Council Reference: DA04/1527.08 LN42053 Your Reference: DA282-11-2004-I-Mod-4

Tweed Shire Council Submission - Australian Bay Lobster Producers (ABLP) Response to Submissions DA 282-11-2004-i Mod 4

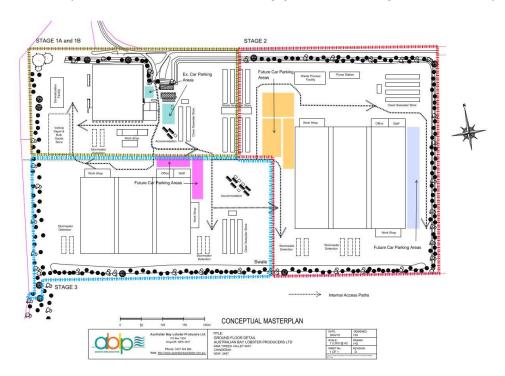
Council's previous comments noted that the pipeline section proposed for realignment is approximately 50m north of the Cudgen (Old) cattle dip site, which is recorded as remediated. However, contamination had not been addressed by the proponent and accordingly was requested to address the DIPMAC due diligence questions.

The proponent's RTS has sought clarification as to the extent of Council's request with respect to further DIPMAC due diligence.

Any development within a 200m radius of a cattle dip site is constrained until human and health risks have been assessed and any rehabilitation is undertaken. It does not appear that any previous assessment of the cattle dip site has been undertaken by the proponent. An assessment should be undertaken in accordance with the Cattle Tick Dip Site Management Committee (DIPMAC) guidelines and relevant NSW Environment Protection Authority (EPA) contaminated land guidelines. The assessment may or may not include soil sampling.

It is recommended that a new condition to this effect be applied by the Department.
